Subject: TRIMMED: Attention Alex Keller - Objection to amended DA2022.1164 34-

Re: Development Application No DA2022/1164

34-35 South Steyne Manly

Objection to further amended proposed development

VIEWPOINT 01 633

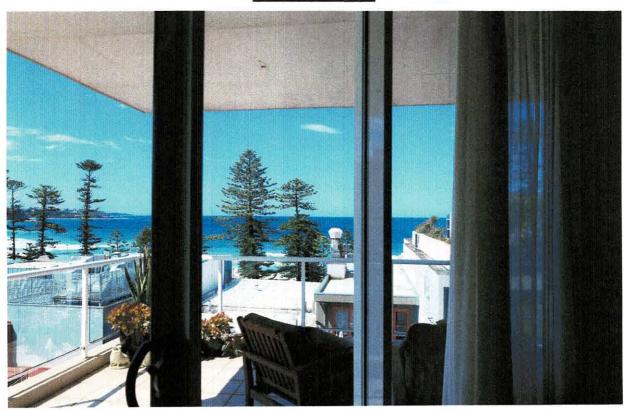
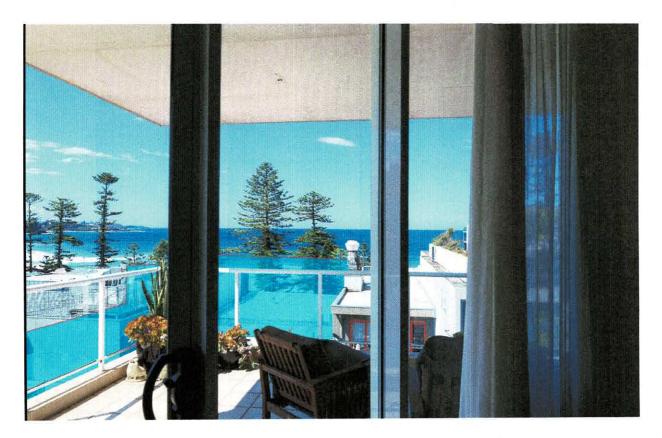
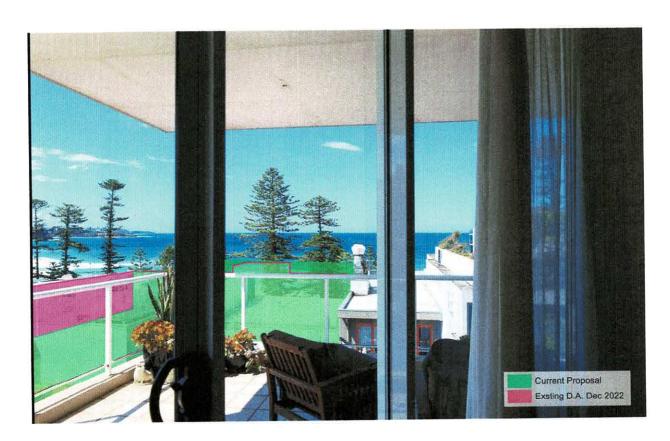
It is reasonable to conclude after examining the View Impact Assessment Report prepared by Urbaine Design Group dated August 2023 that the latest amendments to the proposed development have increased the view loss impacts for both Apartments 633 and 733, as evidenced by their view assessments attached at **Attachment 1**.

The direct land/water interface views to the east of Manly Beach currently enjoyed from both apartments is totally lost – assessed by Urbaine as "moderate" impact - with the justification that distant ocean and headland views to the north offset the direct views to the east in the context of the totality of views under the *Tenacity Consulting* planning principle.

Such a conclusion is flawed as the distant district views are significantly of lessor value (in terms of quality of view) than the direct views to Manly Beach looking east.

Figure 1 - Elevation extracts showing the building height breaching elements on the 10 metre and 12 metre height limit affected portions of the site.

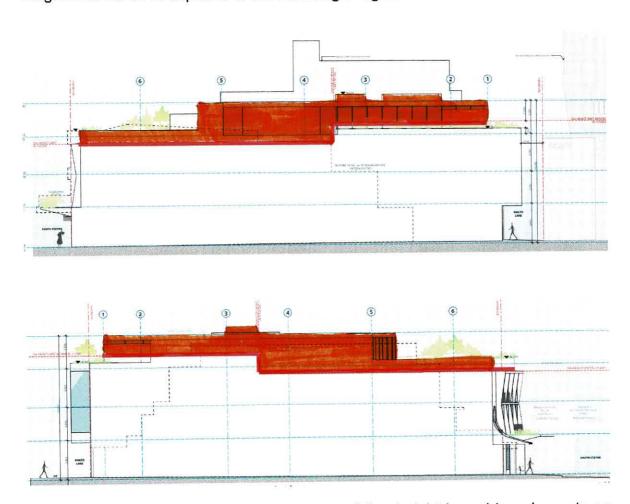
The proposed development does not comply with the 10 and 12 metre height standards applying to the site under Clause 4.3 of the Manly LEP 2013. The extent of non-compliance is as follows:

Control 10.00 metres - RL15.00; proposal - RL16.30 (+13%) (front façade) and RL19.00 (+40%) (level 3 commercial);

Control 12.00 metres -RL17.00; proposal - RL19.00 (+16.6%) and lift overrun RL19.70(+22.5%).

It is the 40% non-compliance with the 10-metre building height standard that has the direct effect on the view losses to the east to Manly Beach currently enjoyed from both Apartment 633 and Apartment 733, as evidenced by the Elevations at **Attachment 2**.

Within the portion of the site that is subject to the 12 metre height limit, the proposed Level 3 roof has a height of 14.2 metres representing a variation of 2.2 metres or 18.3% with the lift overrun and integrated screened mechanical plant area having a maximum height of 14.7 metres representing a variation of 2.7 metres or 19.2%.
